# 1. RESPONSE TO FDA COMMENTS ON CMC DATED NOVEMBER 01, 2021

Our review of your August 24, 2021 submission (STN 125752/2) is ongoing. We havethe following requests for additional information:

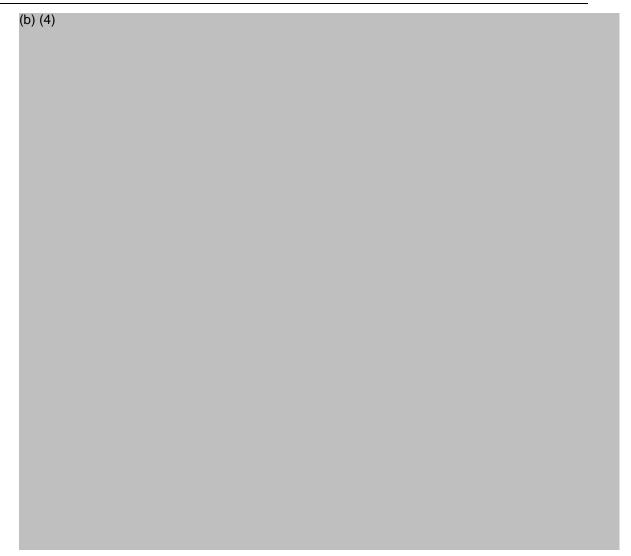
Regarding the hold studies to support the process durations, you indicated that the CPD at CRT (TOR 15 to 25°C) and total CPD were challenged during PPQ toestablish the routine manufacturing hold limits with results presented for (b) (4) DPlots (b) (4) (b) (4) ) in section 3.2.P.3.5.1.3.5 Hold Time Qualification, Tables 26 and 27, and in the above cited PPQ report. We have the following comments regarding the validation study-

The Hold Study in Section 3.2.P.3.5.1.3.5 Table 26 and Table 27 (Lots (b) (4) was conducted by pulling samples of filled vials (b) vials) immediately after filling/stoppering/capping and placing them aside for Hold Duration Study. The subsequent duration of exposure for Hold study vials was based upon the process duration (Elapsed process time at CRT and 2-8°C) that they had already experienced by the fill/stopper/cap step.

(b) (4) of the vials were held at CRT for an additional period of time, until their total CRT duration reached (b) (4) with vials being sampled at each of these timepoints. Thus, these vials represent CRT duration up to (b) (4) (but only the actual elapsed 2-8°C duration).

The study design is illustrated below

Note that the remainder bulk of the batches (b) (4) were processed per routine and experienced the CRT durations (b) (4) as noted in Table 11.23 and Table 11.24 (VPPQ-256-100-00003-S).
